Diode L4448, Resistor (R1, or R1 and R2 in series), and capacitor C 100nF.

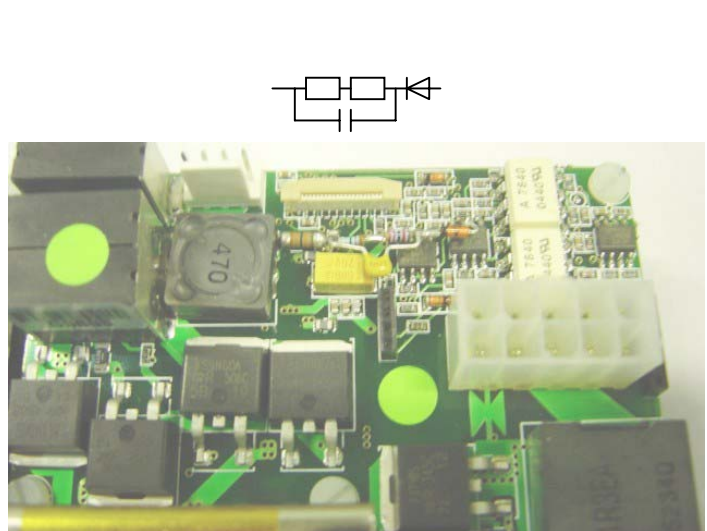
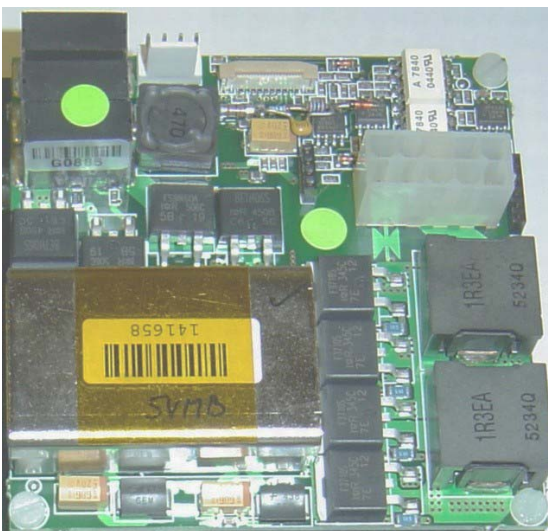
3V bricks [BLUE DOT ●] TO ADD ONLY DRC circuit (D + R1=22k + R2 =1k) and C=100nF

Brick is mounted on the black heatsink

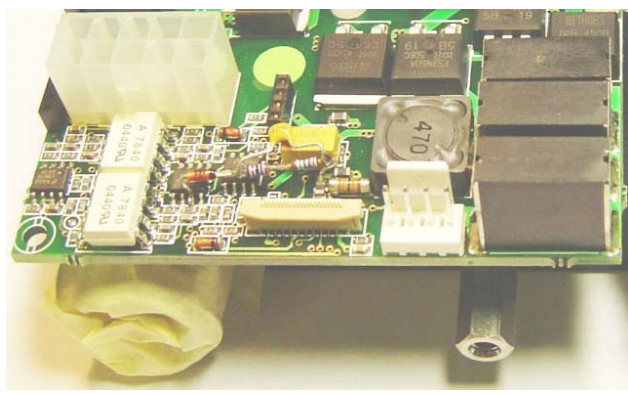
5V MB bricks [TWO GREEN DOTS ●●] TO ADD ONLY DRC circuit (D + R1=22k + R2 =3k3) and C=100nF

Brick is mounted on the black heatsink

5V DIG bricks [GREEN DOT ] TO ADD OLNLY DRC circuit (D + R1=22k + R2=2k2) and C=100nF

Brick is mounted on the black heatsink.

4bricks mounted on a heatsink

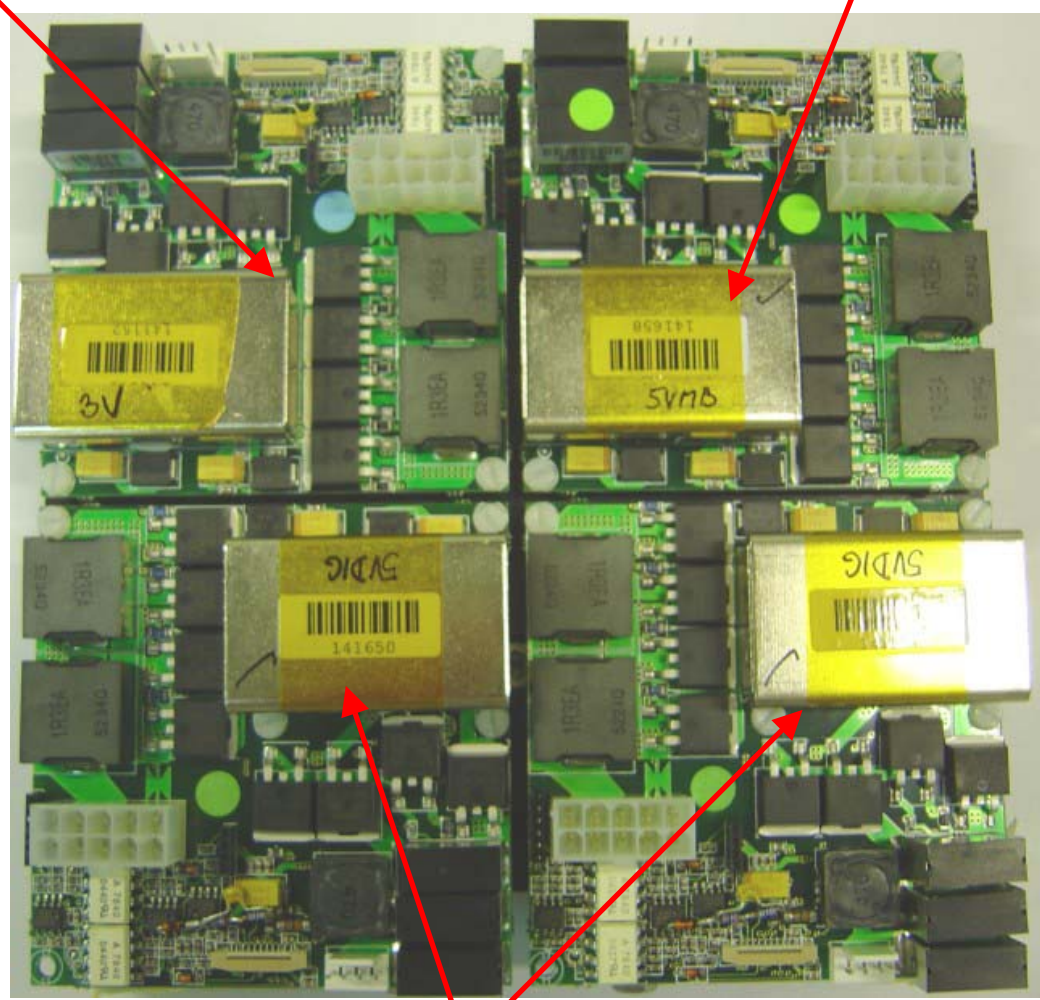
3V brick

5VMB brick

2x 5VDIG bricks

TOP side photos

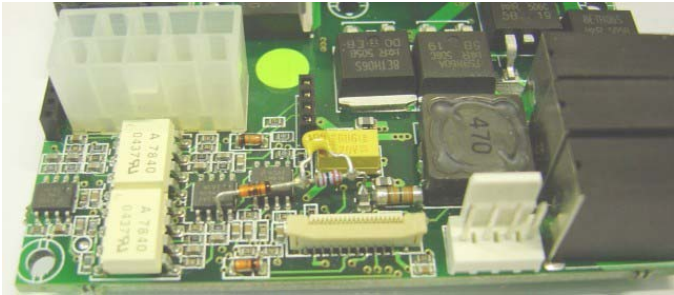
5V HV brick [GREEN DOT] TO ADD DRC circuit (D + R1=22k) and C=100nF AND CHANGE SMD Capacitor 47pF for 150pF on the back side

Back side photo

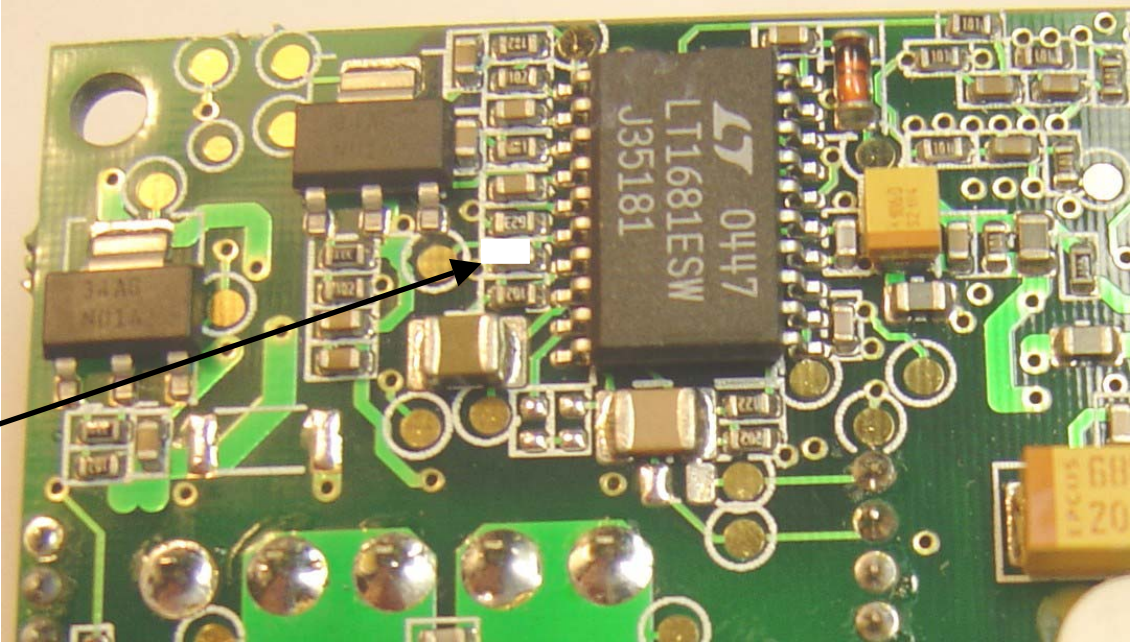
Change SMD Cap 47pF For 150pF

Topside photos

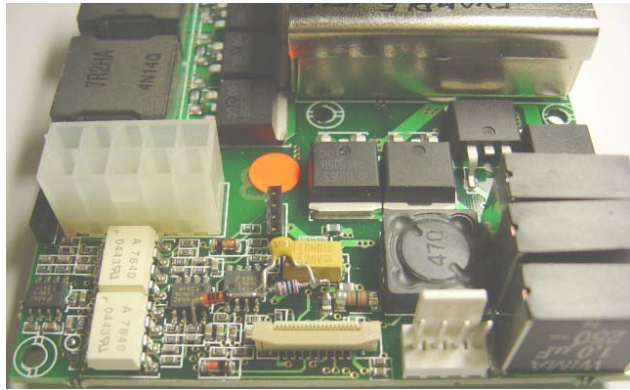
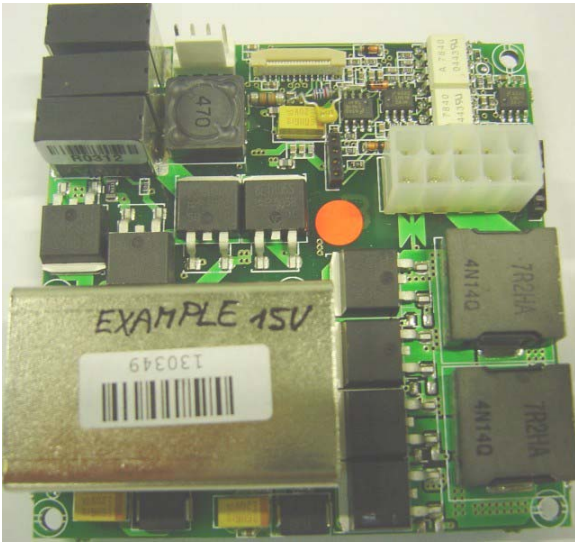
15V bricks [RED DOT ●] TO ADD DRC circuit (D + R1=20k) and C=100nF AND CHANGE SMD Capacitor 47pF for 150pF on the back side

Back side photo

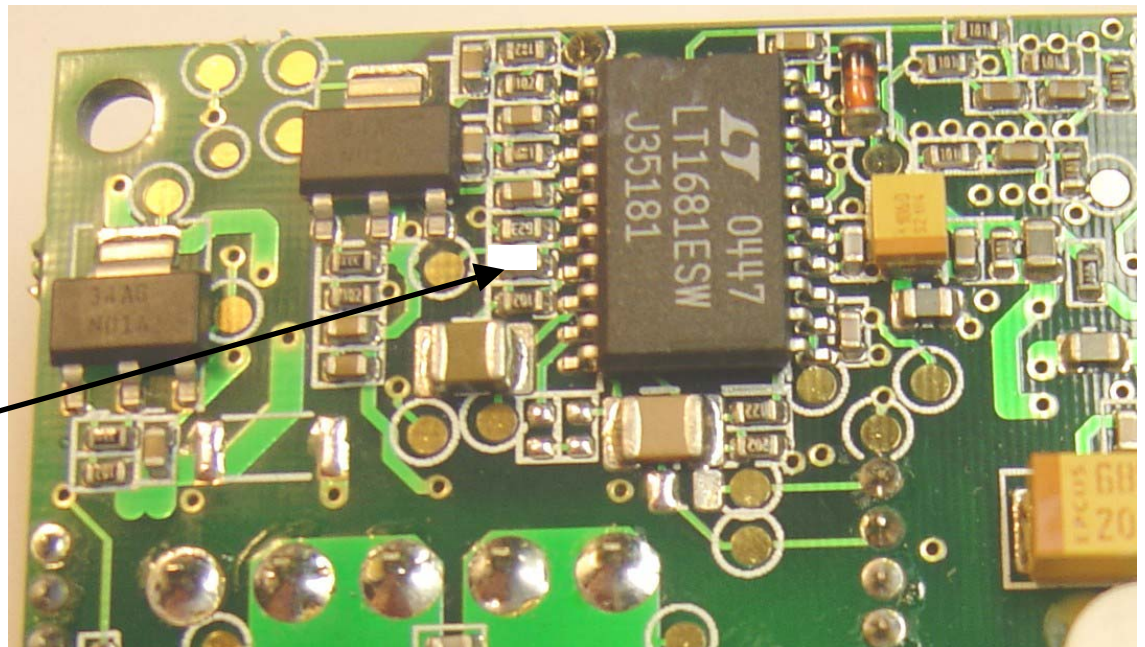
Change SMD Cap 47pF For 150pF
